UNITED STATES PATENT AND TRADEMARK OFFICE

Office Action Summary

10/523,584

DUPONT ET AL.

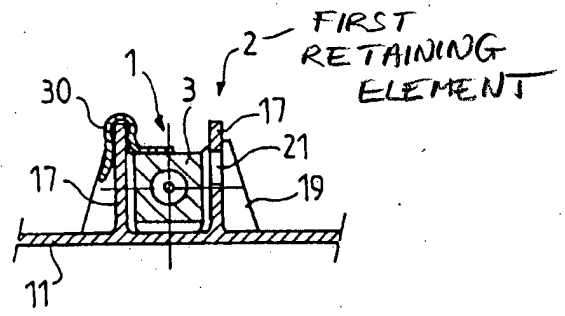
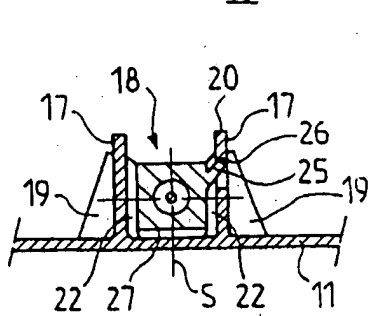
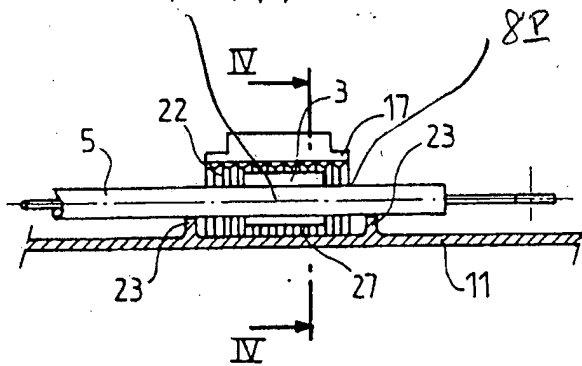
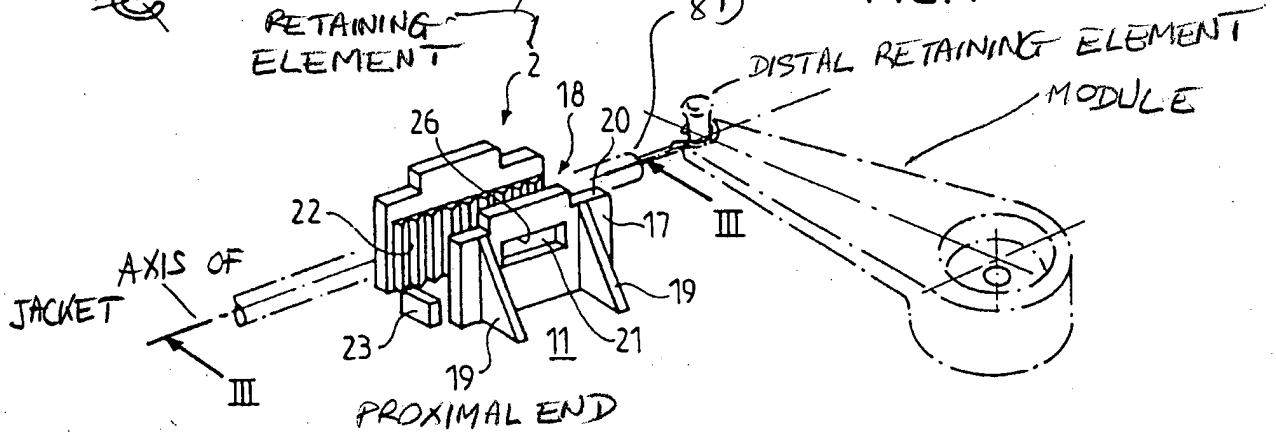
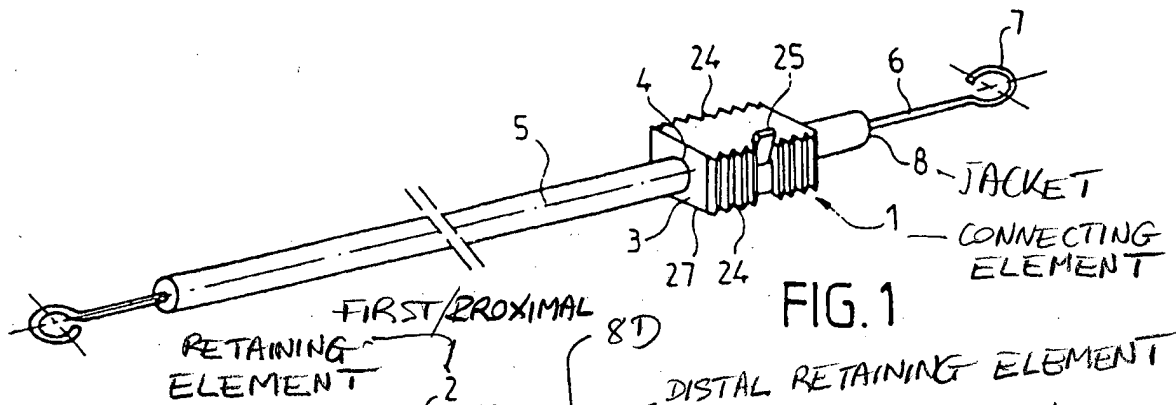
Regarding Claim 1, Michel teaches a control device for a module (unnumbered, shown by dashed line in Fig. 2. See Attachment hereinafter “Att.”) forming a lock mechanism, comprising a cable 6 having two ends, a proximal end (Att.) and a distal end respectively, said cable 6 being housed in a jacket 8 having two ends, a proximal end (8P in Att.) and a distal end (8D in Att.) respectively, which are immobilized by two proximal and distal retaining elements (FIG. 2 in Att.), wherein at least a first end (8P in Att.) of the jacket 8 is connected to a corresponding first retaining element 2 by means of a connecting element 1 attached to the first end of the jacket 8, wherein a weld interface 22 is provided between the connecting element 1 and the first retaining element 2 at a location offset laterally from an axis (III-III in FIG. 2) of side jacket 8. The weld interface 22 is capable of avoiding deformation of the jacket 8 during a welding process.

FIG. 5

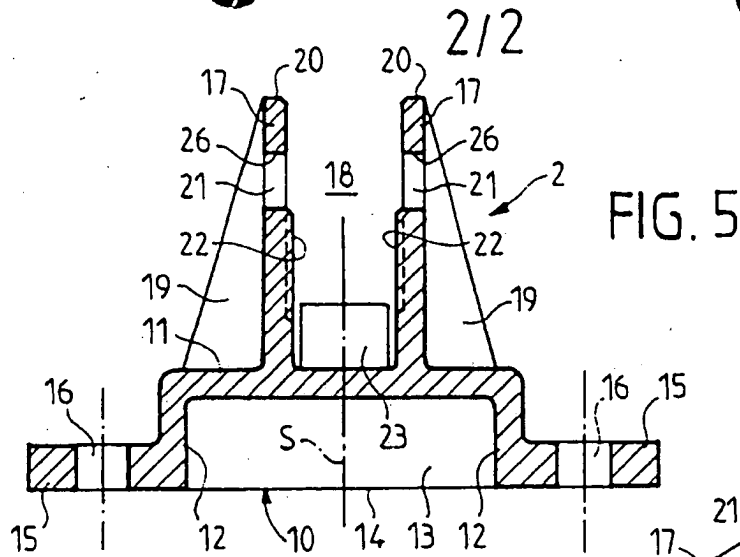
Regarding Claim 6, the interlocking part 24 of the first retaining element 2 forms a longitudinal channel 18 (Fig. 5) for the interlocking of the connecting element 1, the welding face 22 of the first retaining element 2 forming a base of the channel 18, the fusible ribs 22 of the first retaining element 2 extending longitudinally.

FIG. 6

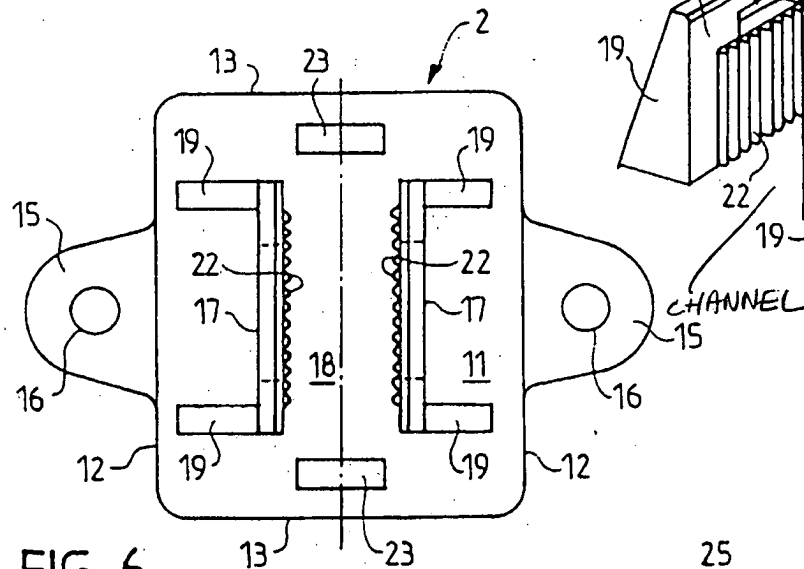
Regarding Claim 8, the first retaining element 2 contains two fusible ribs 22 extending longitudinally on either side of the jacket 8 and two fusible welding shoulders 20 extending longitudinally on either side of the jacket 8, the fusible ribs 22 and the fusible welding shoulders 20 of the first retaining element 2 thus being offset laterally with respect to the axis (III-III in FIG. 2) of the jacket 8 as seen in FIGS. 4, 6, and 10.

FIG. 9

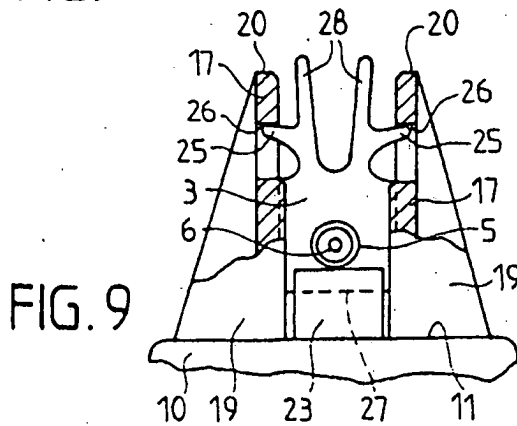
Regarding Claim 7, the complementary interlocking parts 24 and 22 of the connecting element 1 and of the first retaining element 2 comprise fusible complementary welding shoulders 28 and 20 (Fig. 9).

Regarding Claim 15, said weld interface 22 comprises ribs 22 extending longitudinally on either side of the jacket 8 (FIG. 4) and two welding shoulders 28 and 20 (FIG. 9) extending longitudinally on either side of the jacket 8.

FIG. 8

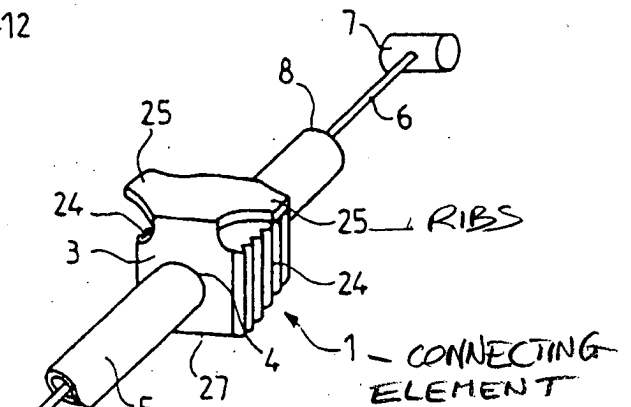
Regarding Claim 11, the proximal end (8P in Att.) of the cable 6 is provided with a block 7 (Fig. 8) for securing this cable 6, the shell 12 forming a housing for the securing block 7.
